EN 1991-1-7:2006/AC

Eurocode 1 - Actions on structures - Part 1-7: General actions - Accidental actions

This corrigendum becomes effective on 17 February 2010 for incorporation in the three official language versions of the EN.

Figure C.3 - Load-time function for ship collision, respectively for elastic and plastic ship response".

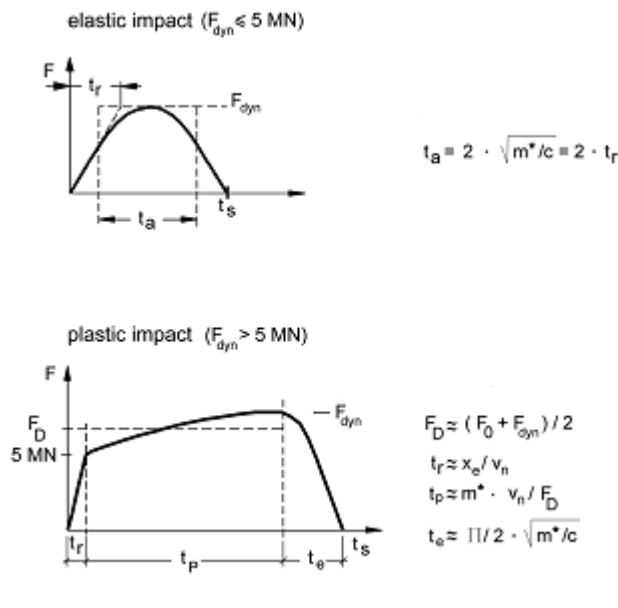
17)Modification to C.4.3

Paragraph (6), replace the whole Figure C.3 with the figure below:

Key:

- t_r elastic elapsing time [s];
- t_p plastic impact time [s];
- t_e elastic response time [s];
- t_a equivalent impact time [s];
- t_s total impact time [s] for plastic impact $t_s = t_r + t_p + t_e$;
- c elastic stiffness of the ship (= 60 MN/m);
- F_0 elastic-plastic limit force = 5 MN;
- x_e elastic deformation ($\approx 0,1$ m);
- v_n a) the sailing speed v_r , for frontal impact;
b) velocity of the colliding ship normal to the impact point $v_n = v_r \sin \alpha$ for lateral impact;

For frontal impact the mass m^* to be taken into account is the total mass of the colliding ship/barge; for lateral impact: $m^* = (m_1 + m_{hydr})/3$, where m_1 is the mass of the directly colliding ship or barge and m_{hydr} is the hydraulic added mass.
